## CITY OF SEBASTOPOL CITY COUNCIL AGENDA ITEM

Meeting Date:	January 21, 2020	
To:	Honorable Mayor and Honorable City Councilmembers	
From:	Henry Mikus, Engineering Manager	
Subject:	Approval of Caltrans Request to Eliminate Three Crosswalks and Build a New	
	Crosswalk Along SR 116/Petaluma Avenue	
Recommendation:	Adopt a Resolution Approving Caltrans Request to Eliminate Three Crosswalks and	
	Build a New Crosswalk Along SR 116/Petaluma Avenue	
Funding:	Currently Budgeted: Yes NoX_ N/A	
	Net General Fund Cost: None, All costs shall be paid for by Caltrans	
Account Code/Costs author	orized in City Approved Budget N/A (verified by Administrative Services Department)

X - REMOVE CROSSWALK

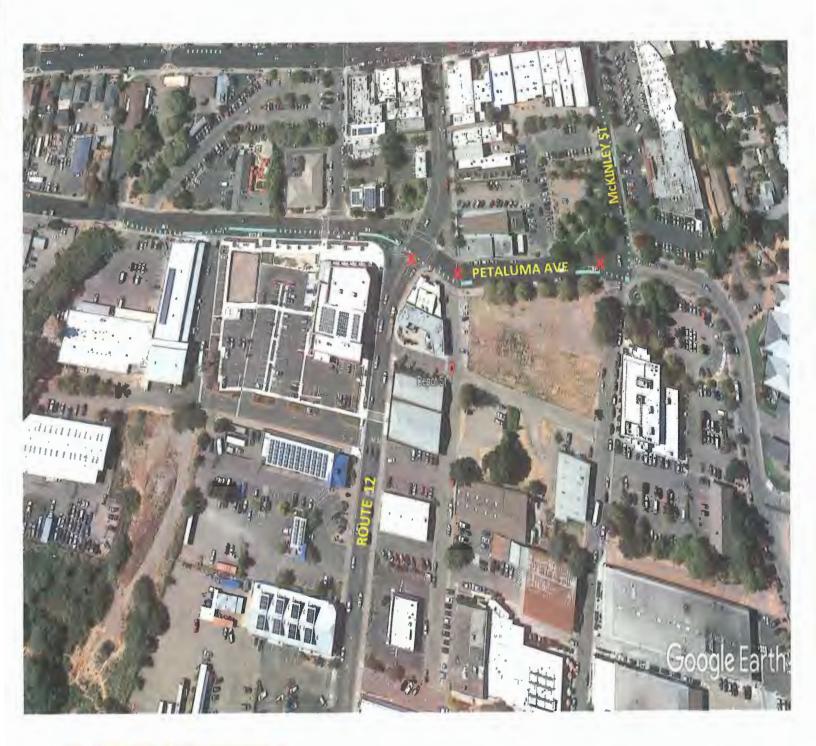
- 1. Eliminate three extant crosswalks:
  - a. Across SR12 Sebastopol Road at SR116 Petaluma Avenue; postmile marker 009.290 on SR12 and postmile marker R026.820 on SR116
  - b. Across Depot Street at SR116 Petaluma Avenue; postmile marker R026.810 on SR116
  - c. Across SR116 Petaluma Avenue at McKinley Street; postmile marker R026.730 on SR116
- 2. Replace the three removed crosswalks with a new crosswalk on SR116 Petaluma Avenue at Weeks Way which is the entrance to La Plaza Park; postmile marker R026.770 on SR116.
